Notice and Agenda
Brigham City Council Meeting
Thursday, October 15, 2026 6:00 PM
City Council Chambers, 20 North Main
To View Live Meeting Visit:
https://www.bcutah.gov/mayor-and-city-council.htm **or**
www.youtube.com/brighamcitycorp

1. Consideration of Approval of Heron Ridge Townhome Subdivision Preliminary Plat located at Approximately 650 South 1200 West - Zane Billings

From: Zane Billings, Assistant City Planner

HERON RIDGE TOWNHOMES
PRELIMINARY PLAT

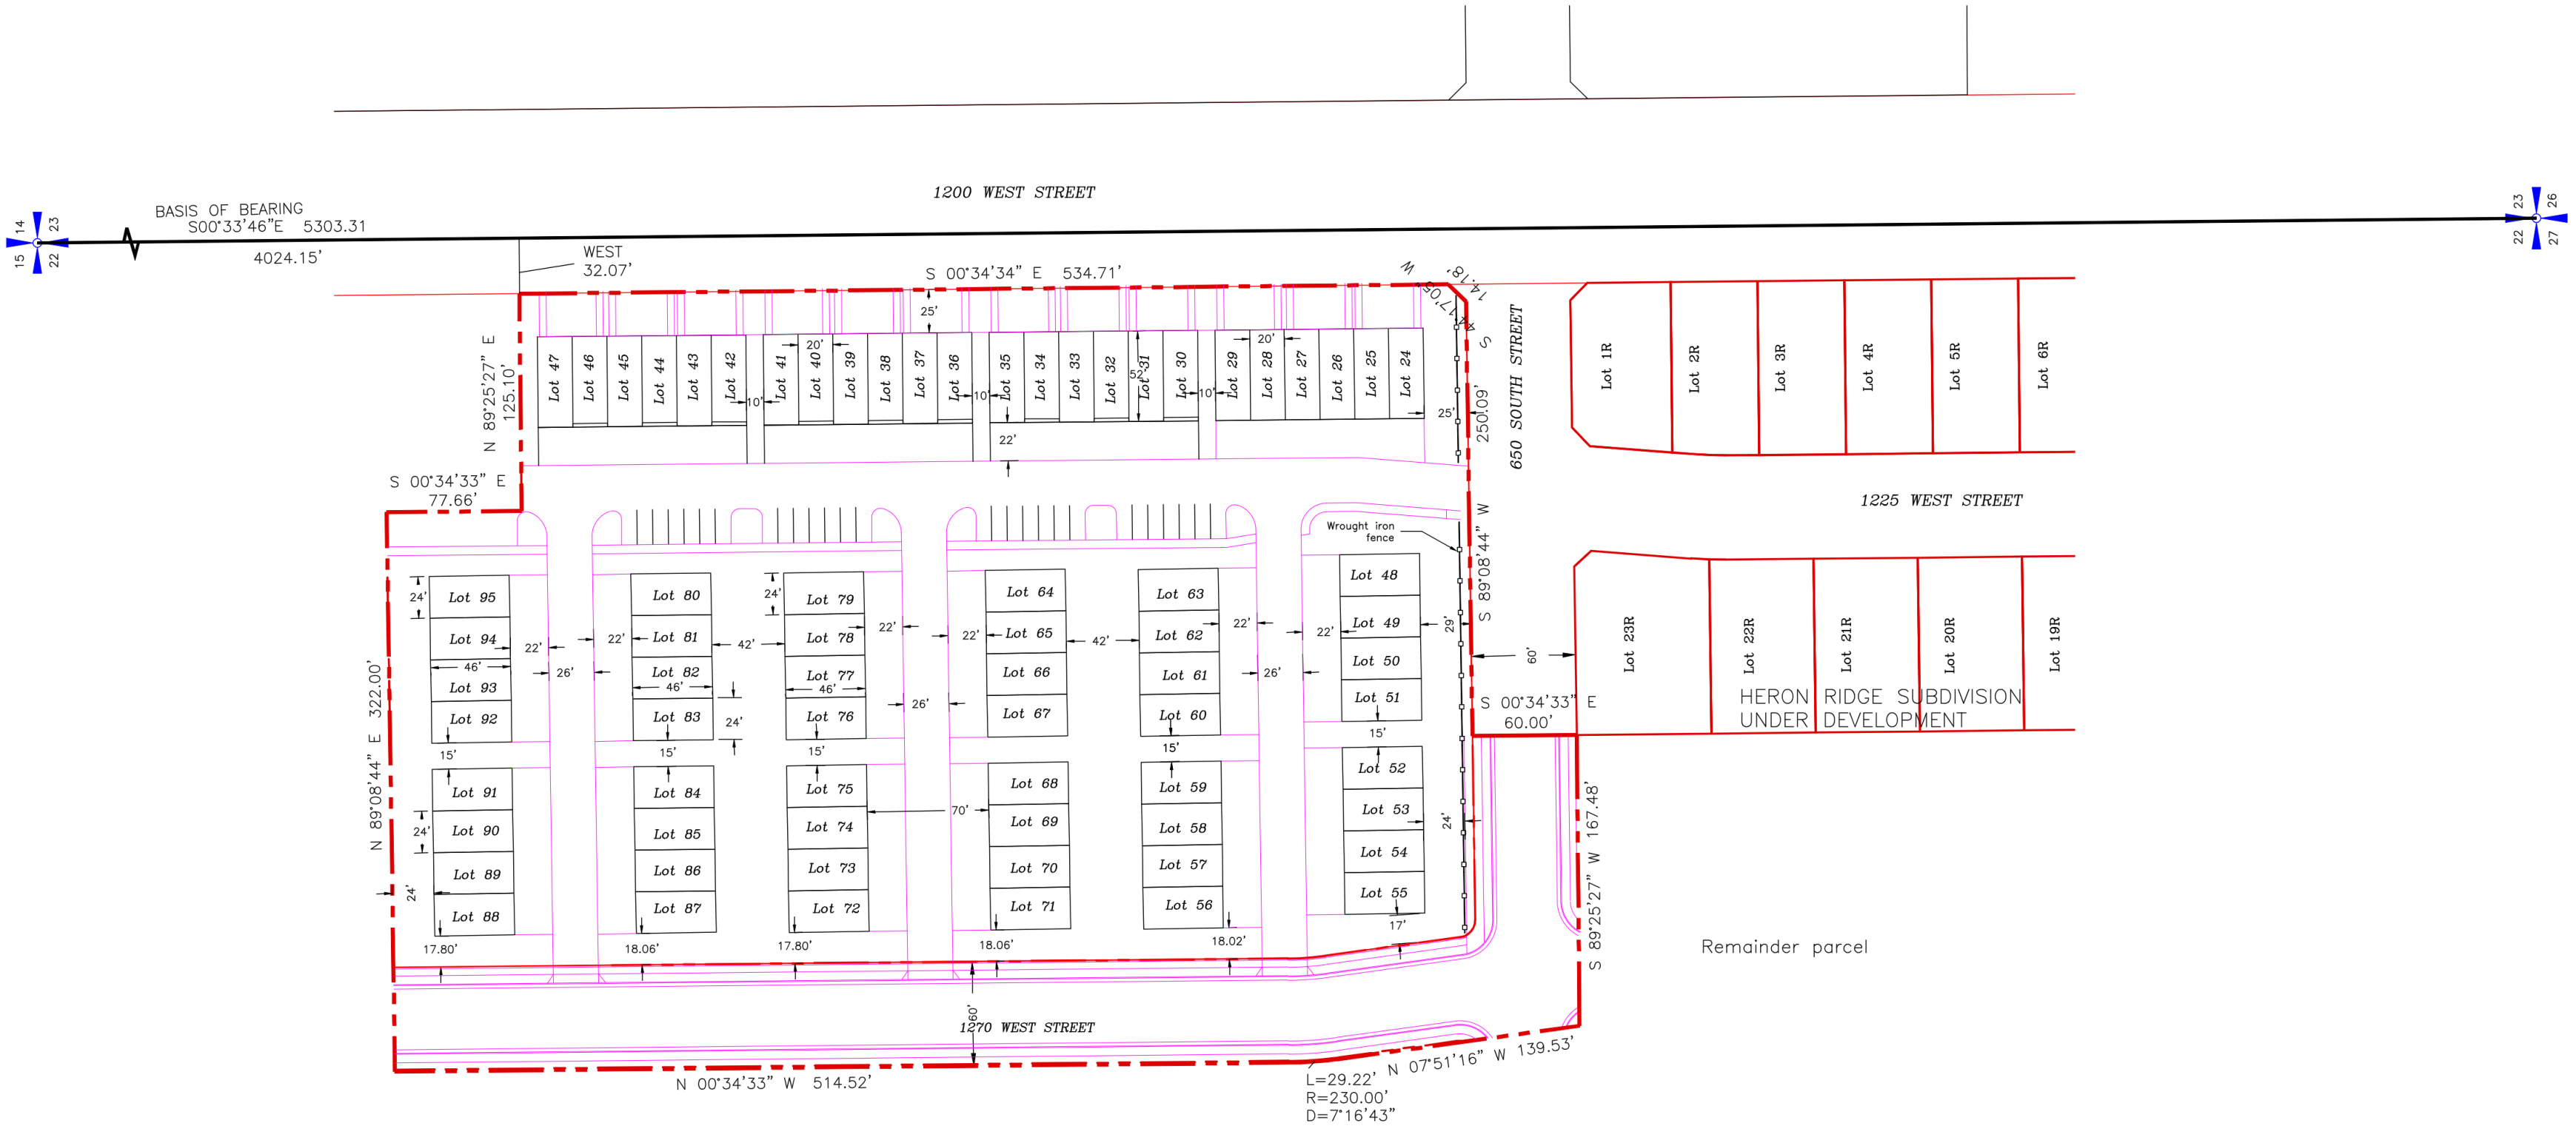
Community and Economic Development Department:
1. Overview.
   A. The plans appear to show a total of 72 townhome units; however, the project notes identify 78 units. Revise the plans and project notes to reflect the correct total number of townhome units.

C. Please verify and correct the quarter section reference. The plan identifies the project as being within the Northwest Quarter of Section 23, while the Boundary Legal Description references the Southeast Quarter of Section 22. Revise as necessary for consistency.

B. Typical 60' Road Cross-Section-650 South. Please label park strip, 10' path, and show location of wrought iron fence. Fence should be one foot off of sidewalk/path so pedestrians and bicycles don't hit the fence or get their handlebar caught in the fence.

C. Landscape. Update landscape plan. Provide actual plans to be submitted with final plat application.
    D. 1200 West.
    A. Show and label wrought iron fence with gabion columns.

B. Units 24 – 47. Show walkways connecting to a pathway behind the fence with tie into the 650 South 10 ft path.
    E. Guest Parking. Label and provide a note to sign guest parking. Also provide, number of required number spaces and provided spaces.

F. Units along 1270 (1275 or 1250) W. Provide a minimum 20 ft setback from the public street.

TYPICAL DRIVE AISLE CROSS SECTION

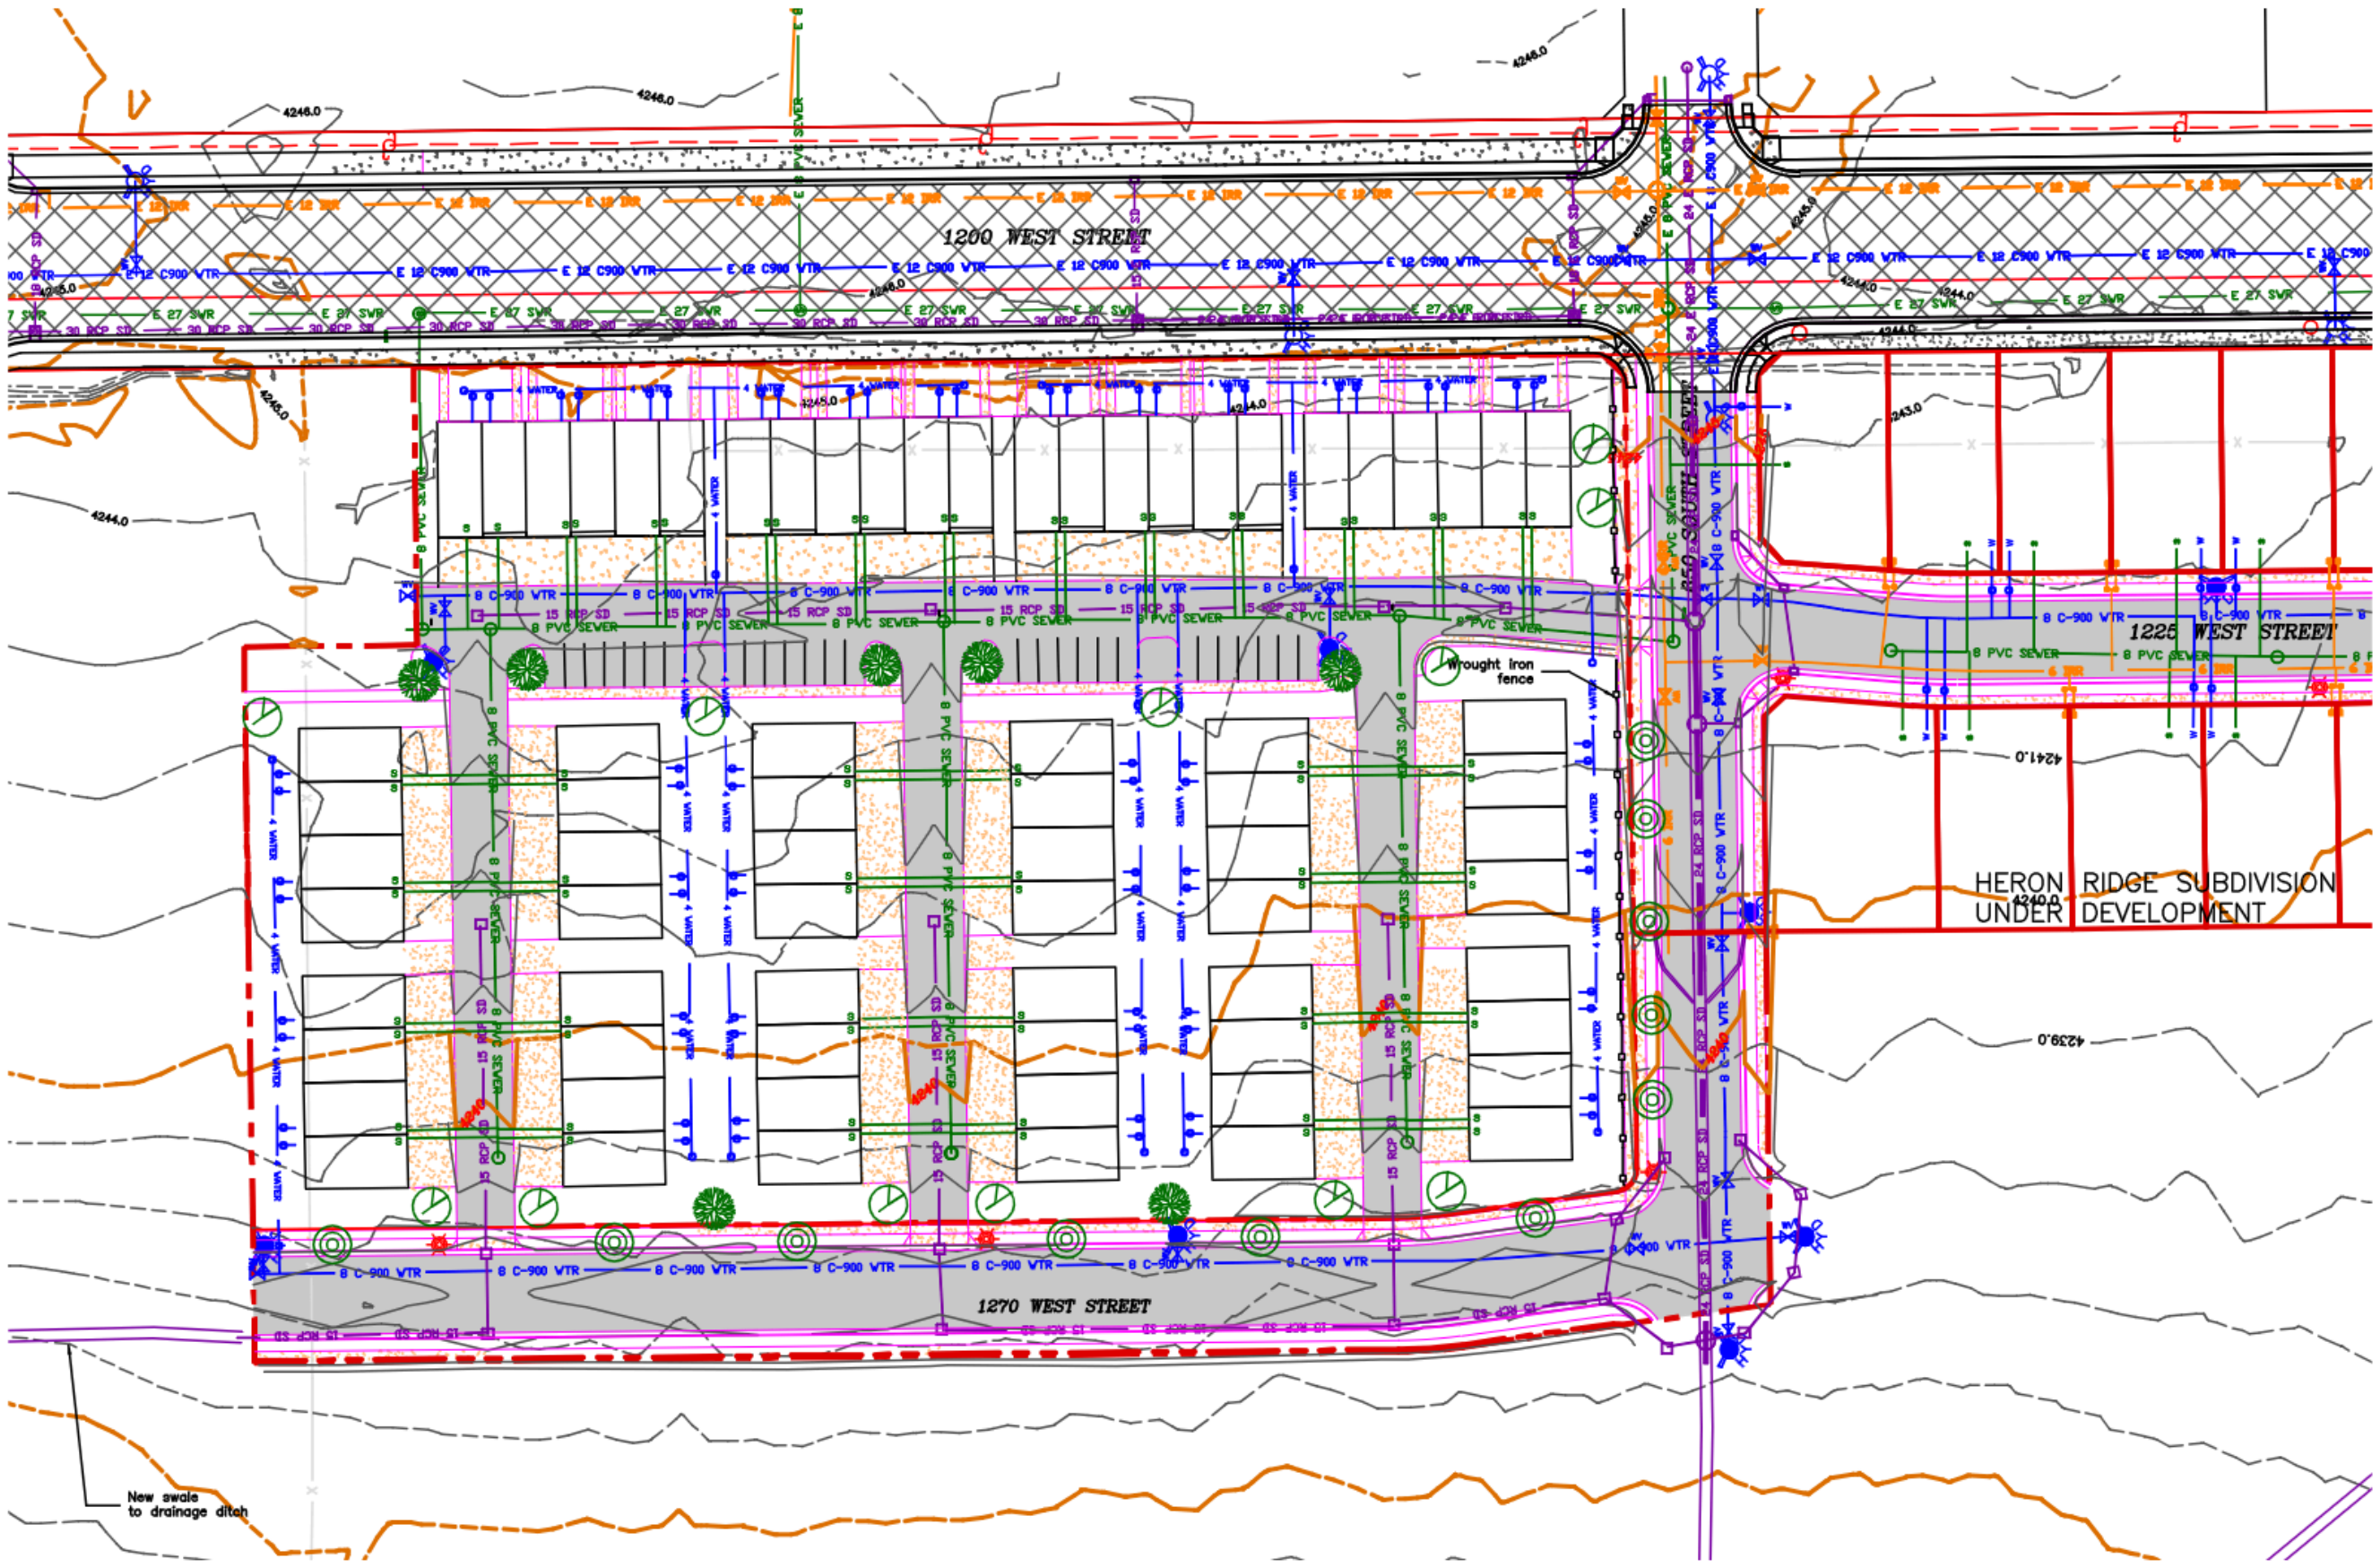
5. Drawing No. 1.
    A. Typical Drive Aisle Cross-section. Include the full dimensions for the private street width and driveway width (minimum 22 ft between garage and back top of concrete ribbon curb.
